Adding charts comments against 802.3cu D2.1 #10, 11

May 19, 2020 Interim Teleconference

IEEE P802.3cu 100 Gb/s and 400 Gb/s over SMF at 100 Gb/s per Wavelength Task Force

Figure 140-x 100GBASE-FR1 transmitter
 OMA_{outer} and receiver sensitivity

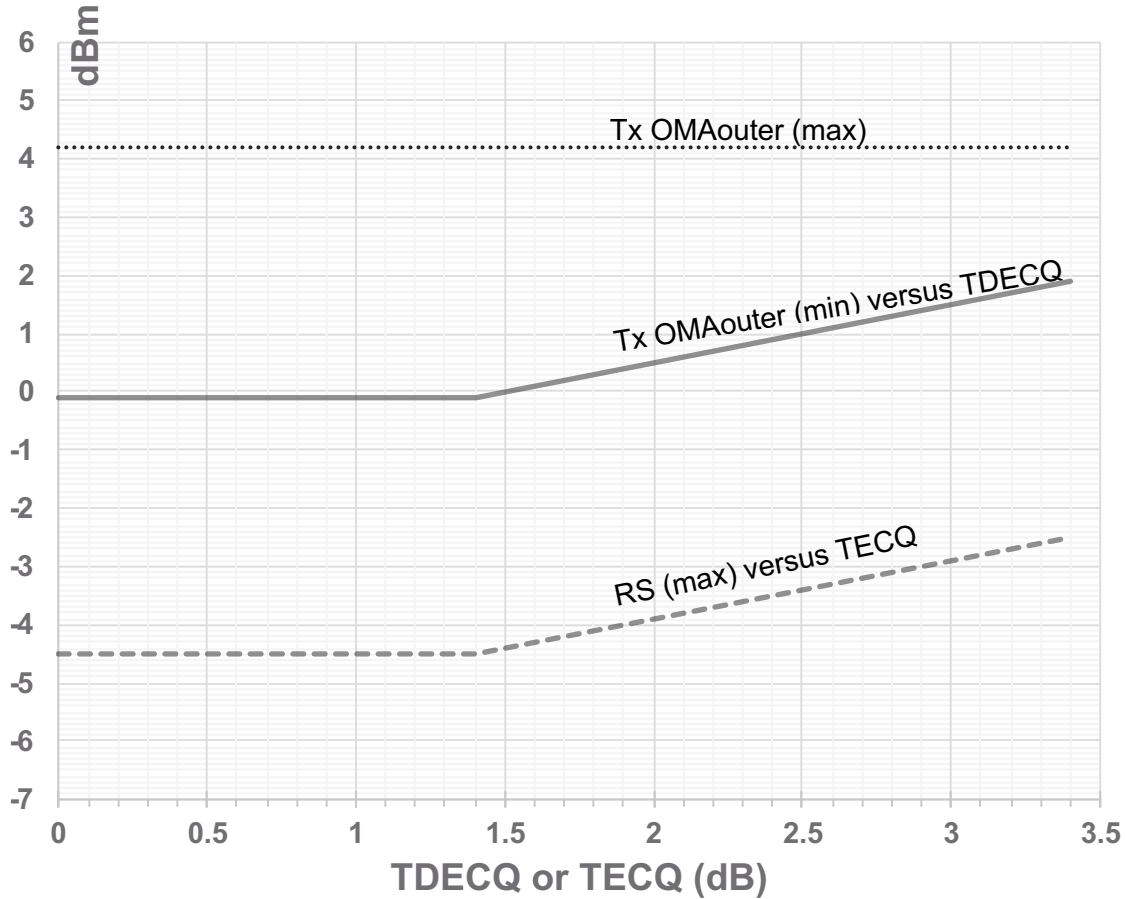
| Technical | 44 | 140.6.3 | 43 | It would be helpful to add a graph showing how OMA _{outer} and RS vary with TDECQ and TECQ respectively. | Insert two graphs after Table 140-8 for 100GBASE-FR1 and 100GBASE-LR1, each showing the variation of Tx OMA _{outer} and RS against TDECQ and TECQ respectively. A presentation in support of this comment will show the form of the two graphs. |

- Comment #10 proposes adding the two charts on page 3 to subclause 140.6.3 after Table 140-8 and with editorial license to reference them.
- Comment #11 proposes adding the two charts on page 4 to subclause 151.7.3 after Table 151-9 and with editorial license to reference them.
- Alternative A would instead add the chart for Tx OMAouter on page 5 to subclause 140.6.1 the chart of RS on page 5 to subclause 140.6.2. Similar charts would be added to 151.7.1 and 151.7.2 with editorial license.
- Alternative B would instead add the chart on page 6 to subclause 140.6.3 with editorial license to reference it. A similar chart would be added to 151.7.3 with editorial license to reference it.

Figure 151-x 400GBASE-FR4 transmitter
OMA_{outer} and receiver sensitivity

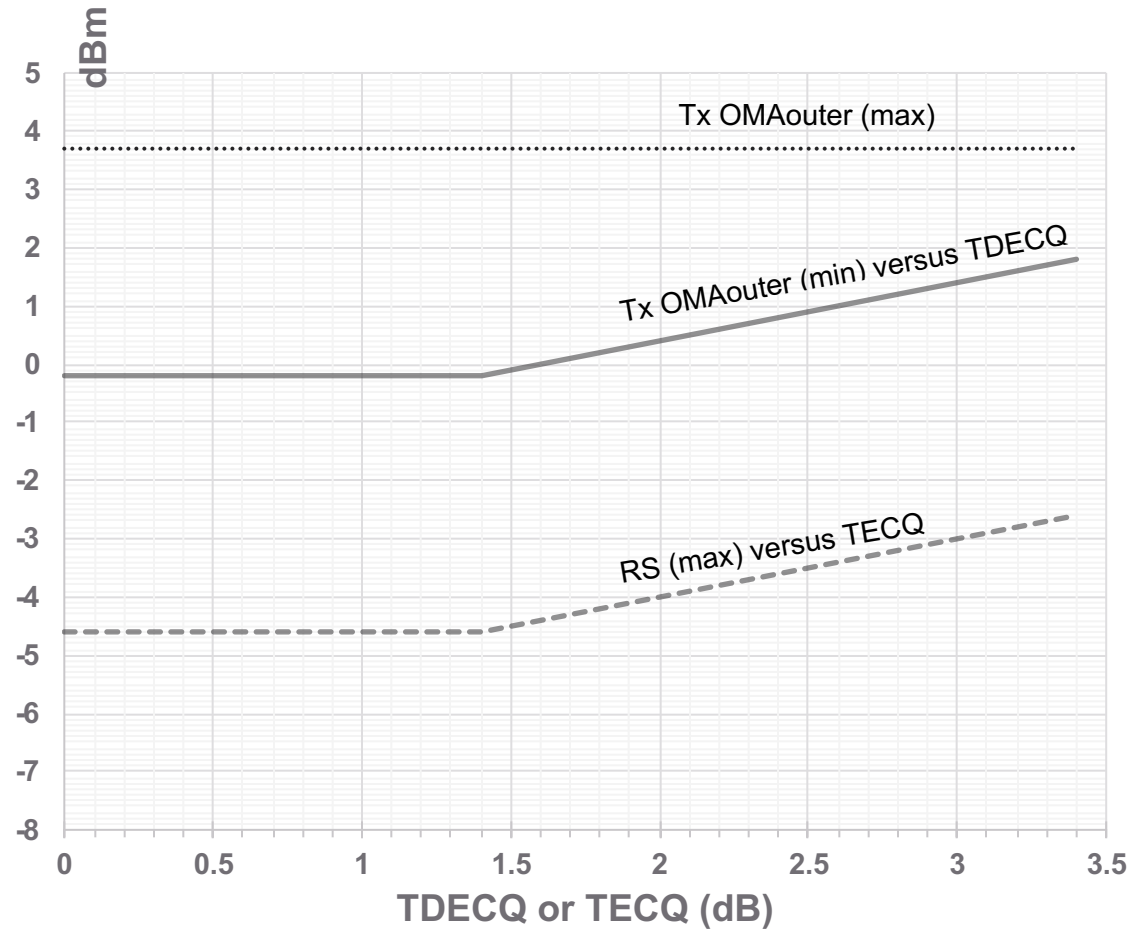
| Technical | 67 | 151.7.3 | 27 | It would be helpful to add a graph showing how OMA _{outer} and RS vary with TDECQ and TECQ respectively. | Insert two graphs after Table 151-9 for 400GBASE-FR4 and 400GBASE-LR4-6, each showing the variation of Tx OMA _{outer} and RS against TDECQ and TECQ respectively. A presentation in support of this comment will show the form of the two graphs. |

Figure 140-x 100GBASE-FR1 and 100GBASE-LR1 transmitter OMA_{outer}

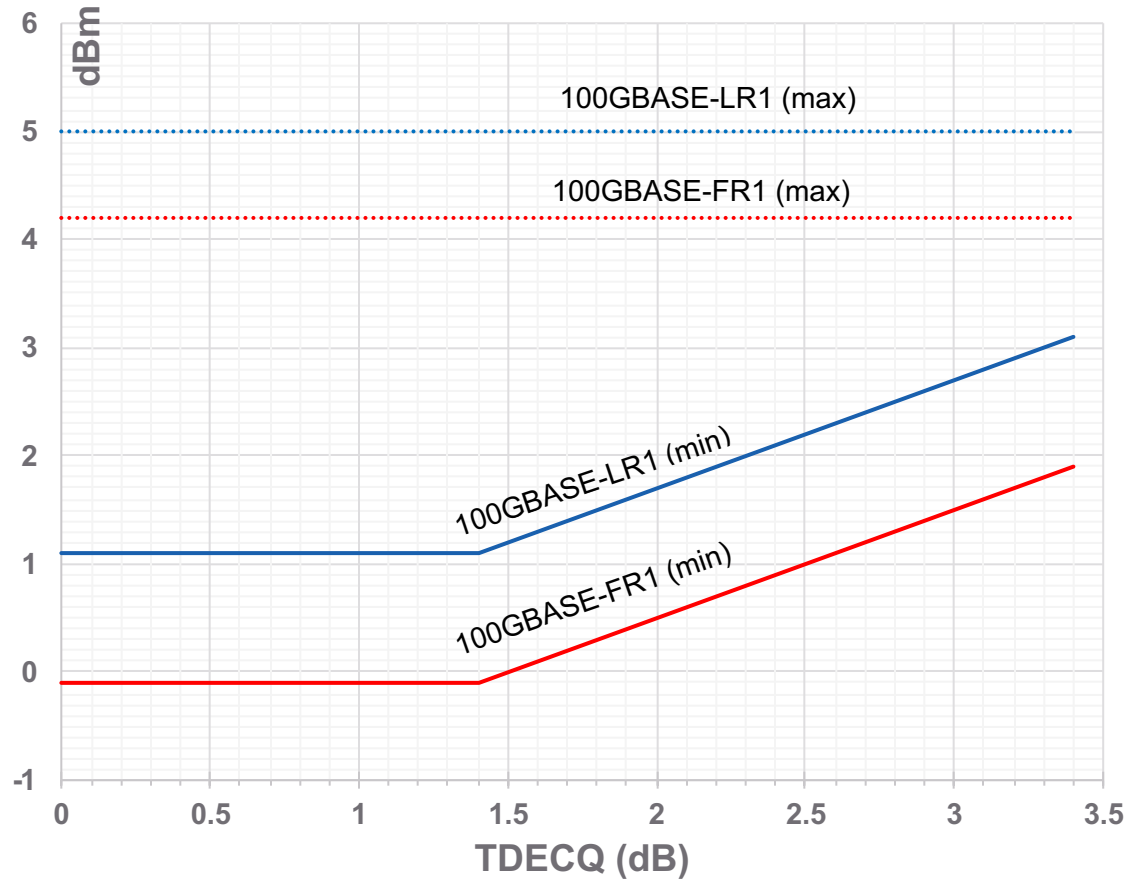
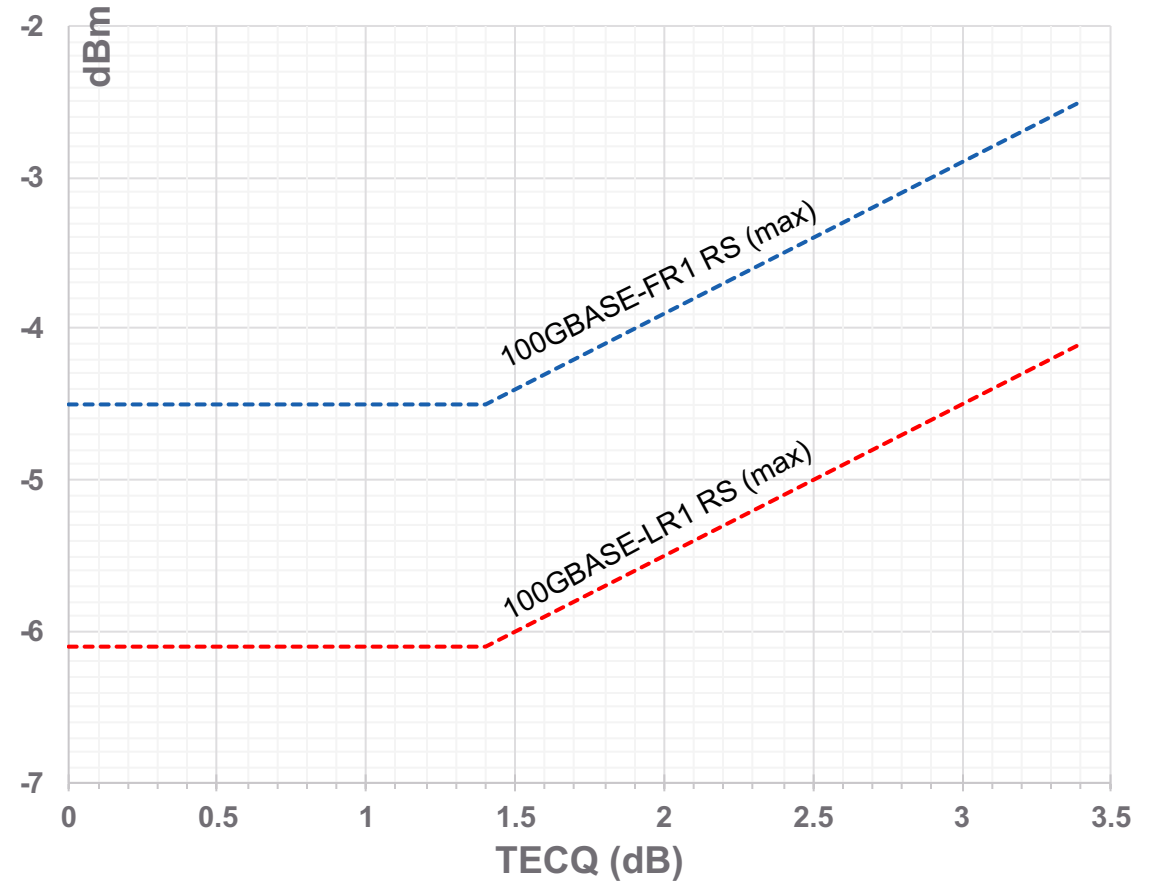
Alternative A: separate Tx and Rx charts (similar charts in clause 151)

Figure 140-x 100GBASE-FR1 and 100GBASE-LR1 transmitter OMA_{outer} and receiver sensitivity

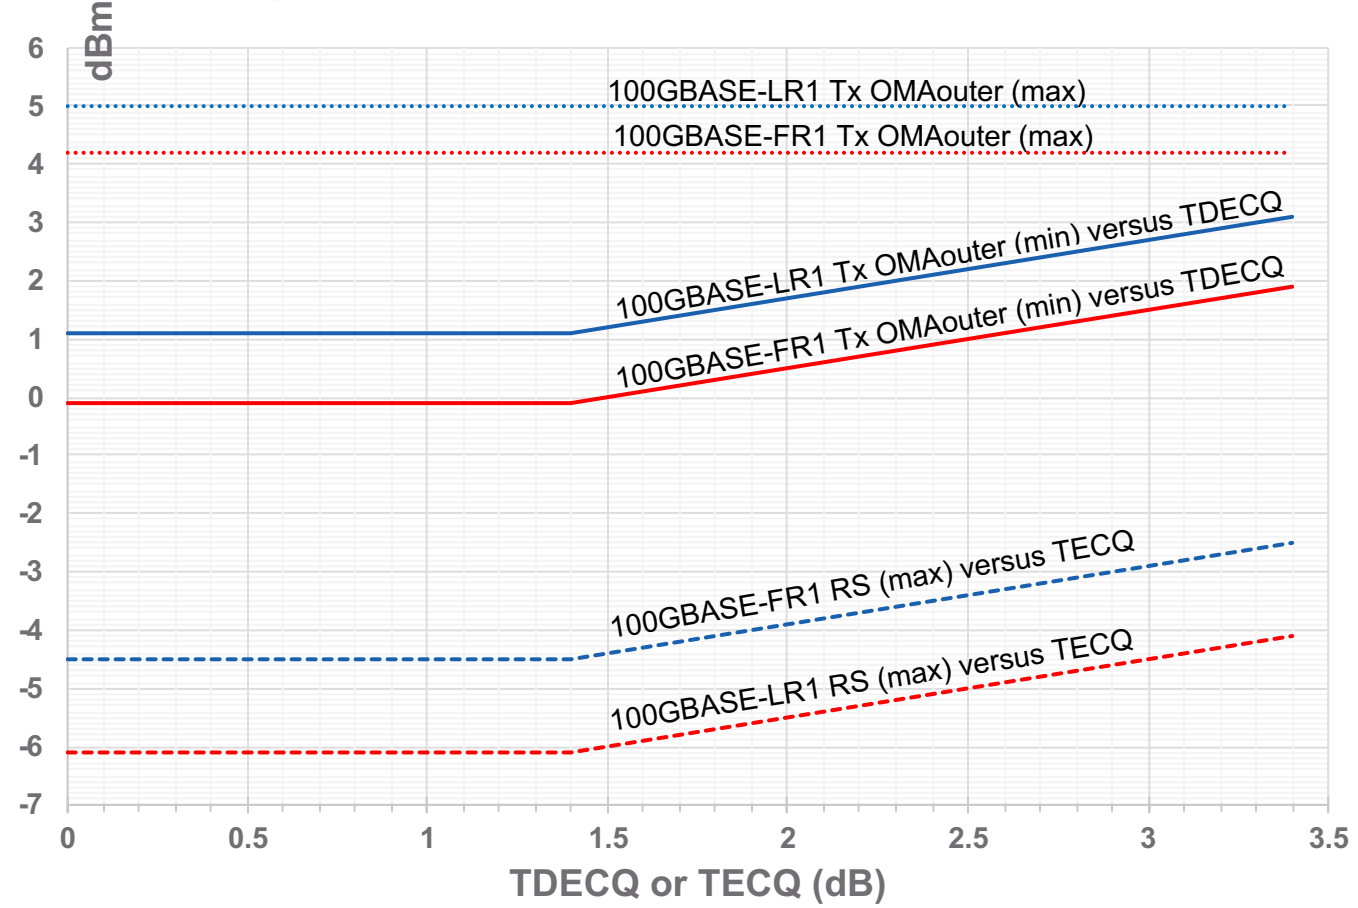
Alternative B: All in one chart (similar chart in clause 151)
